TAC Meeting – March 3, 2008
Announcements from the Chair

Welcome to the March meeting of the Wastewater Technical Advisory Committee.

TM - Flows & Loads (February 2008)

SEWER PLANNING
RATIO OF PEAK FLOW
TO AVERAGE DAILY FLOW
FIGURE 4-2-1

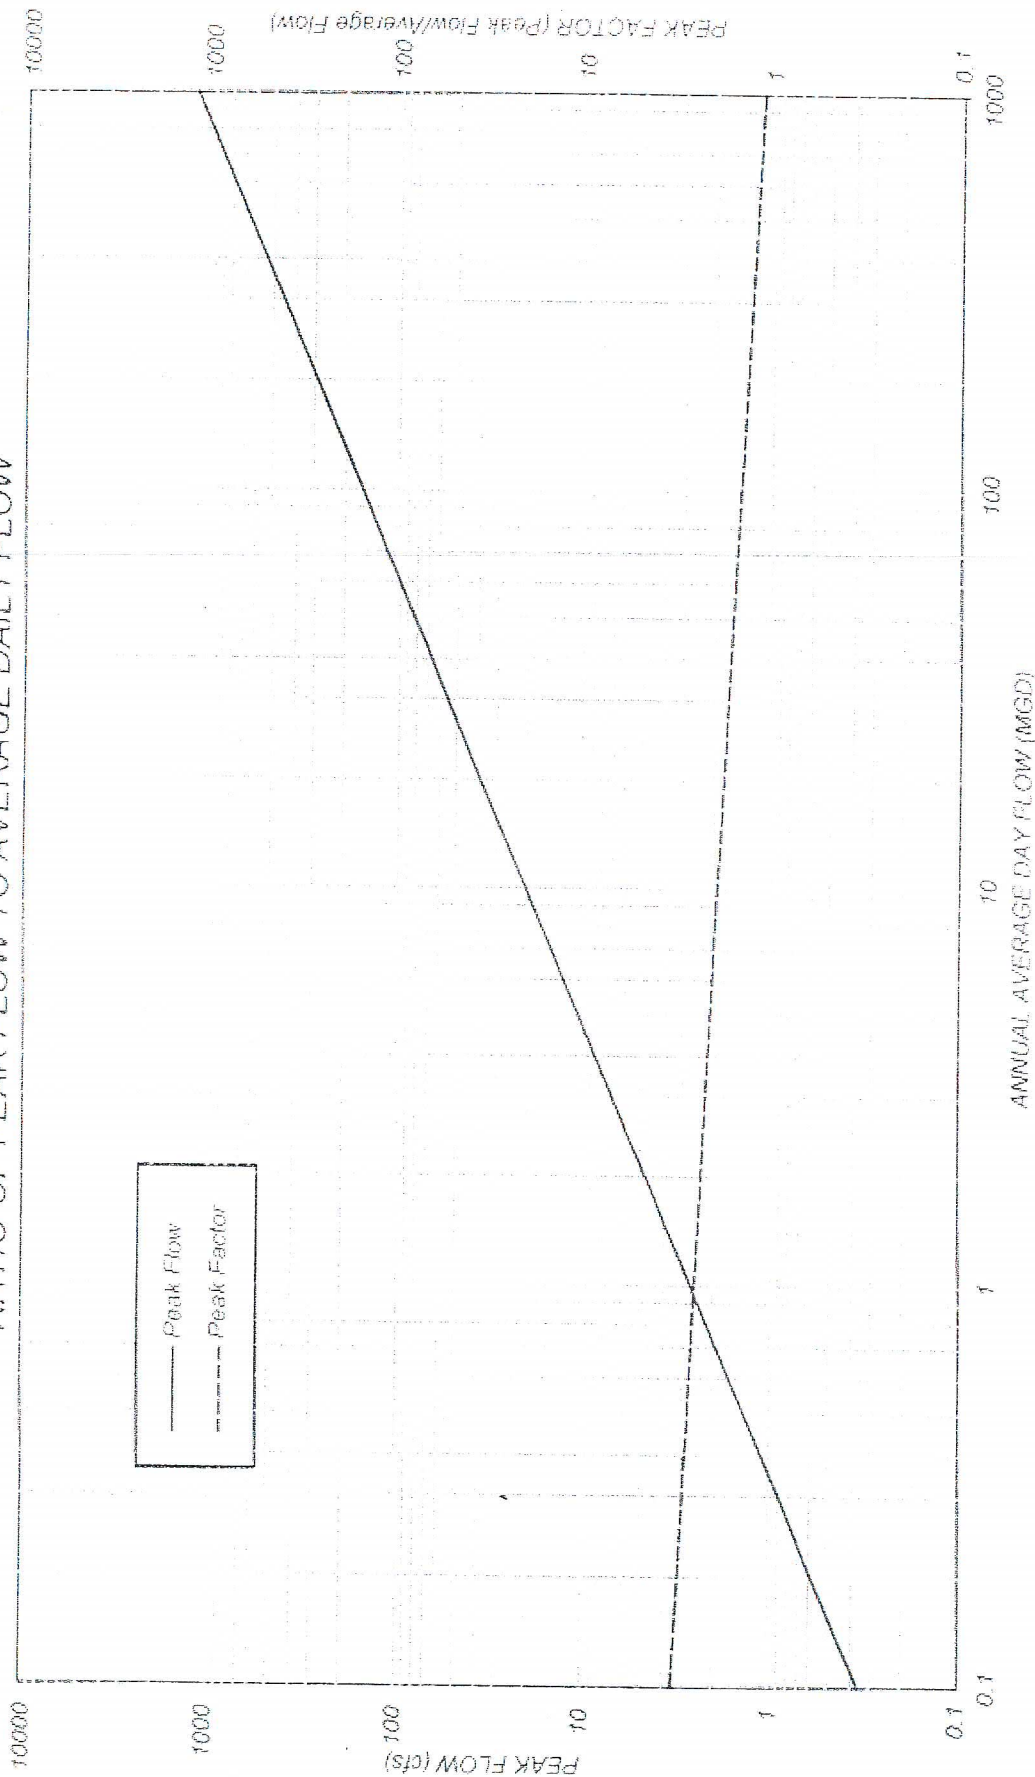
p 10: population 18,428 = 18.43 (thousand)

p 1,2 peaking factor (PF)

PF = 1.8 (gravity) ← ?

PF = 1.4 (step) ← ?

#2/ $PF = 5 P^{-0.16} = 3.14$

#1/ $PF = 5 P^{-0.2} = 2.79$

or $PF = \left(1 + \frac{14}{4 + \sqrt{P}}\right) = 2.69$

#3/ $PF = 2.5$ (low populations)

Av_g = 2.78 ⇒ PF = 2.8 (Los Osos, gravity)

$\frac{1.8}{2.8} = 0.64$ ← → TM-PF = 60-65% of Ref. Values ?

Also - basis for STEP PF ?
